**Service Bulletin**

**No. :** MZ07-056 **Date:** May 16, 2007

Model: SR4001, SR5001

Subject: Part Specification Change: OPT/COAX Complex Jack (both

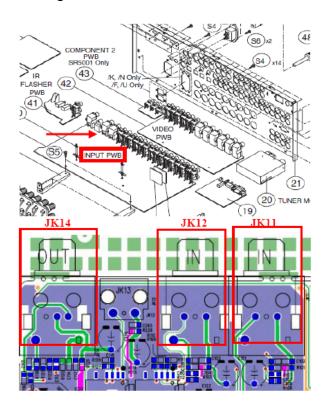
**Solution:** 1. JK11, JK12 (RX) and JK14 (TX) on the INPUT PWB are the parts whose specifications have been changed this time.

2. Due to the configuration difference, the new parts are incompatible with the old ones. Please note that the INPUT PWB and REAR PANEL have to be replaced.
